Flight Procedures Cover Page	Task Action: FLIGHT CHECK	Task Type: IAP	Estimated Chart Date: 08/10/2023	APWS Task ID: EC01224DCD8545AF8F56DD6AFD48706A	APWS Project ID: ED6440C158D84FF0B43726F72CA4391C
Procedure: ILS OR LOC RWY 7L AMDT 5		Enroute: NO	Specialist: Schones, Christopher		Agreement Number:
Airport ID: PANC			Airport City: ANCHORAGE		State: AK
Facility ID: TGN	Facility Type: ILS	Flight Inspection Remark Type: New FC Slot			
Procedure Comments: PANC active airport data used. I-TGN active data used. Contact Casimir Tabaka: 405-954-7931 QUALITY 20 CHECKED QUALITY 33 CHECKED

Memorandum

Subject: Approval Request: TED STEVENS ANCHORAGE INTL (PANC), ILS OR LOC
RWY 7L

ILS OR LOC RWY 7L
TED STEVENS ANCHORAGE INTL ANCHORAGE AK (PANC)

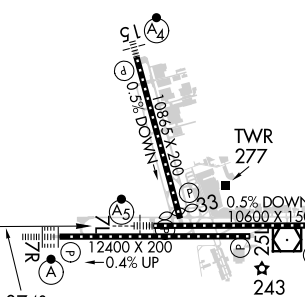
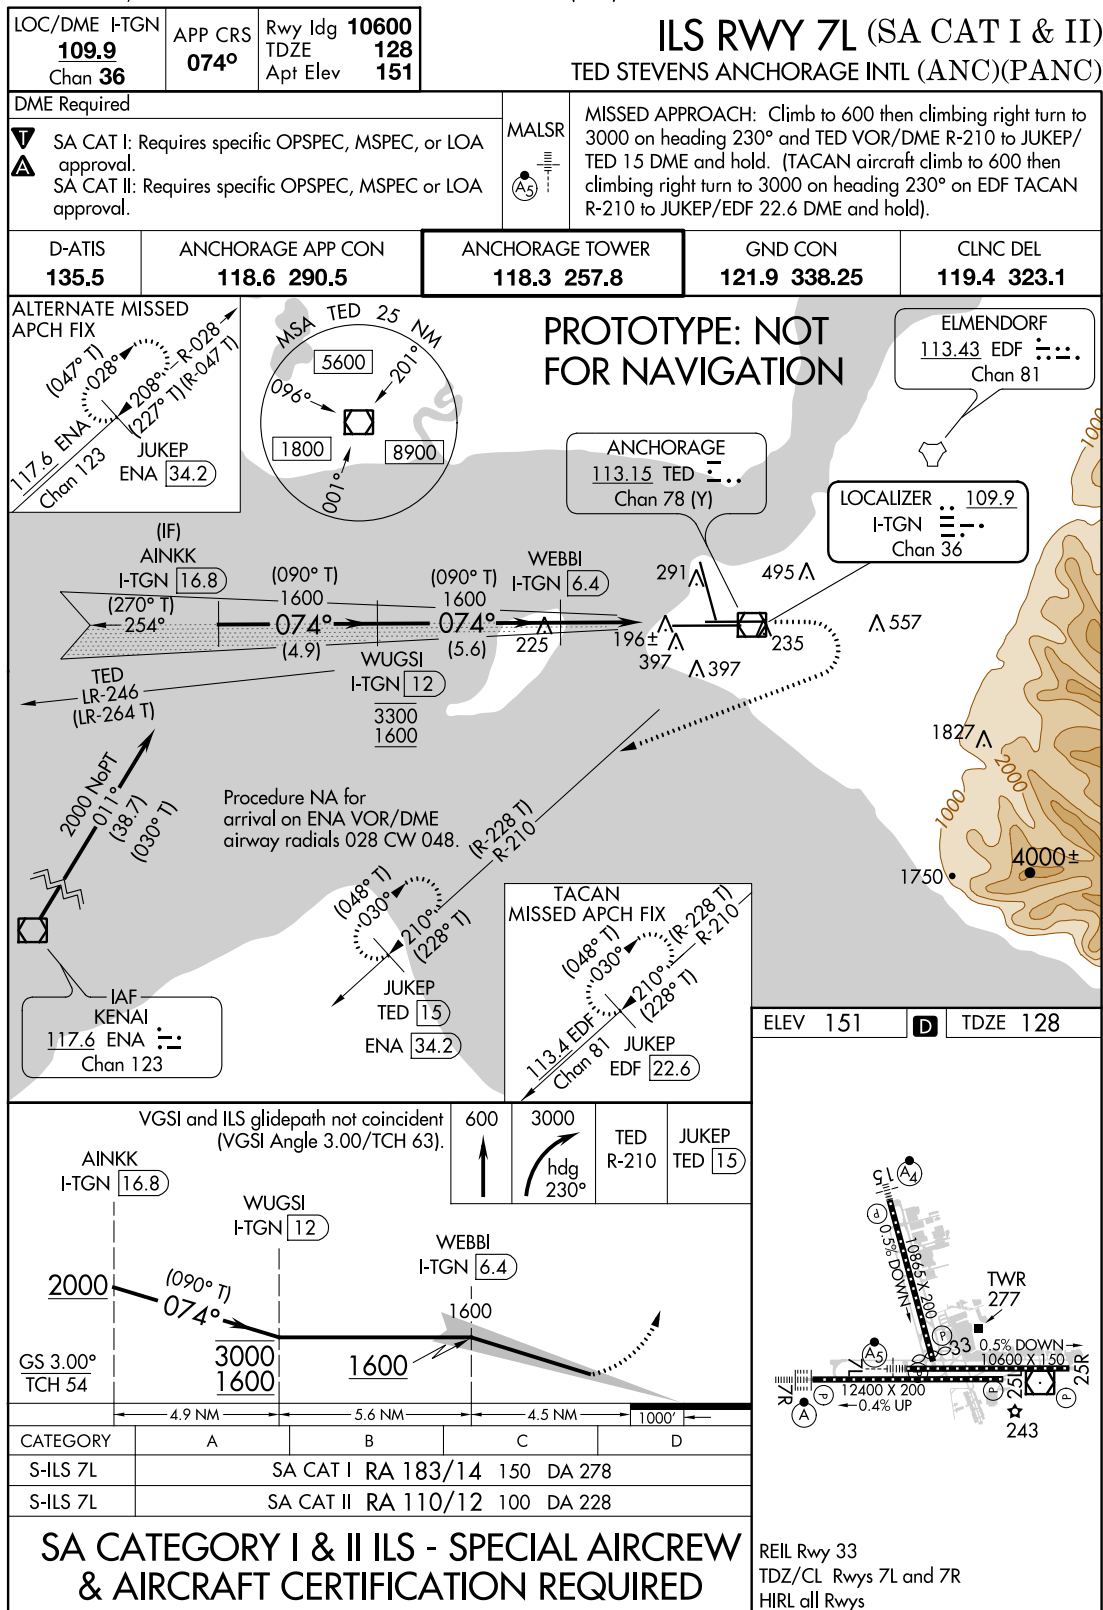
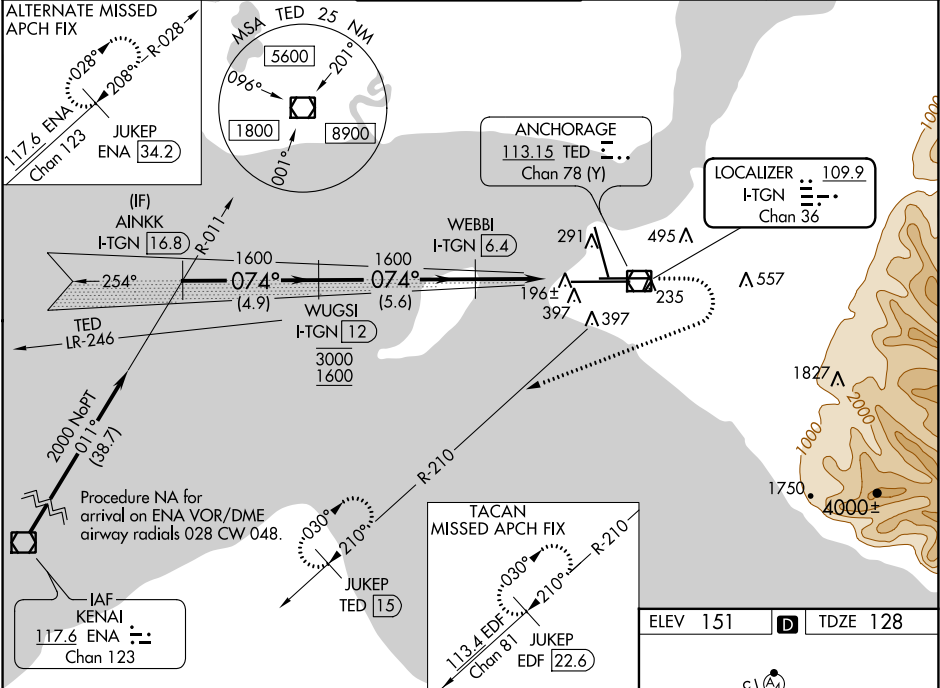
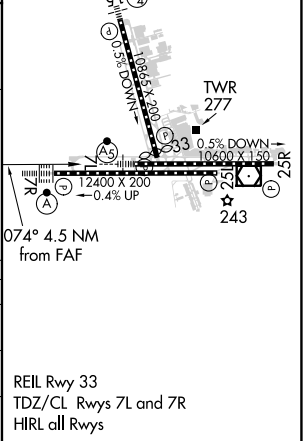
Request approval to amend block altitude on the intermediate stepdown fix due to operational requirement at ATC's request (FAAO 8260.19I). WUGSI with a block altitude was added to the approach due to wake turbulence and to alleviate flow issues. Currently published maximum altitude of 3000 is too low. Request to raise maximum altitude to at or just below glideslope, 3300.
